Report

Consultation on the revision of the TSI relating to accessibility for persons with disabilities and persons with reduced mobility

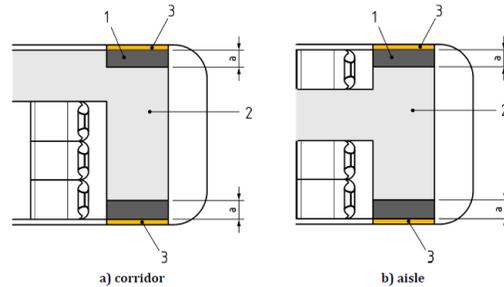
<i>Reference (e.g. Art, §)</i>	<i>Type</i>	<i>Reviewer</i>	<i>Reviewer's Comments, Questions, Proposals</i>	<i>Reply</i>	<i>Proposal for the correction or justification for the rejection</i>
			<p>EDF recommendations: The length of the basic dimensions should be increased from 1200 mm to 1400 mm, preferably even 1500 mm to include mobility scooters, etc. In Denmark DSB has stated the limit of the length of a wheelchair/mobility scooter to be max. 1400 mm, as is the general length of the lifts in buildings and stations, and the length of the Danish boarding lifts used for boarding the trains. Links:</p> <p>https://www.dsb.dk/globalassets/produkter_og_services/pdf/handicapservice_august2017.pdf</p> <p>https://www.dsb.dk/find-produkter-og-services/handicapservice-i-dsb/</p> <p><i>EDF recommendation: The lifting capacity always to be minimum 300kg regardless of type of wheelchair.</i></p>

Figure 7 — Examples of minimum doorway position markings (without entrance steps)

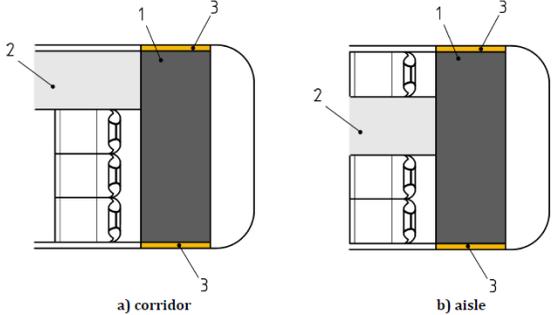
4.2.2.11.2 & 4.2.2.12.1 & 5.3.2.8 & 6.2.3.2	P	Faiveley	<p>Clause 4.2.2.11.2 (4) states that the “As a minimum the first and the last steps shall be indicated by a contrasting band with a depth of 45 mm to 55 mm extending a minimum of 80 % of the width of the steps on the top surface of the step nosing. A similar band shall indicate the front surface of the last step when entering the unit.”</p> <p>Nevertheless clause 4.2.2.11.2 (6) states that “If a step board is fitted and it is an extension of a door sill outside the vehicle, and there is no change in level between the step board and the floor of the vehicle, this shall not be considered to be a step for the purposes of this specification. A minimal drop in level, with a maximum of 60 mm, between the floor surface at door sill and that of the exterior of the vehicle, used to guide and seal the door is also permissible and shall not be considered as a step.”</p> <p>That means that sub-clause (4) related to contrasting band does not apply and that contrasting band are not required.</p> <p>Clause 4.2.2.12.1 - Movable step and bridging plate – does not require contrasting band and refers to clause 5.3.2.8 for additional requirements. Clause 5.3.2.8 - Boarding aids: movable steps and bridging plates – does not require contrasting band on movable steps and bridging plates The conclusion of these clauses is that contrasting bands are not mandatory in case the vestibule and the door sill are at the same level and that</p>	Accepted	We propose to add a reference to EN16584-1 point 5.3.9 in the application guide

contrasting band are not mandatory for movable steps and bridging plates.
 Clause 6.2.3.2 – Step position for vehicle access and egress – which states that the “outer end of the floor at the passenger access shall be considered as a step” does not solve the problem because this requirement is clearly only valid to calculate the gap between the vehicle and the platform.
 To clarify the requirements, our proposal is:
 Clause 4.2.2.11.2 – add in sub-clause (4)
 “The outer end of the floor at the passenger access shall be considered as a step for the purpose of this clause.
 Movable steps and bridging plates shall be considered as a step for the purpose of this clause”

Note : see figures 7 and 8 of EN16584-1 below for a better understanding of the comment
